CRIME IMPACT STATEMENT

REMMETS HOUSE, LORD STREET, BURY
CHANGE OF USE OF GROUND FLOOR TO FORM
SECONDARY SCHOOL FOR 120 PUPILS

FOR: Bury Defence Academy
VERSION A: 20/06/2024
REFERENCE: 2024/0182/CIS/01

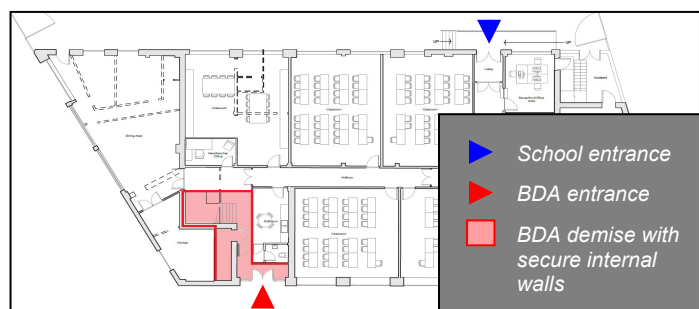
- 3.2.1 The proposed development will bring the vacant ground floor of the building back into use and provide additional activity, overlooking and surveillance to the area during the school day.

- 3.2.2 The proposed school will benefit from some natural surveillance from the surrounding streets – particularly during the day.
- 3.2.3 The car park serving the building is enclosed/secured at night (after the BDA use has finished), deterring unauthorised access to the hidden doors/windows out-of-hours.

- 3.2.4 The car park is laid out in a straight row, allowing clear views over parked vehicles from routinely occupied rooms within the school during the day.

- 3.2.5 The location of the main entrance to the building provides a clear and direct route for visitors and for any parents/guardians dropping off/collecting their children. There will be a staffed reception/office adjacent to the entrance, providing surveillance over everyone entering/leaving the building.
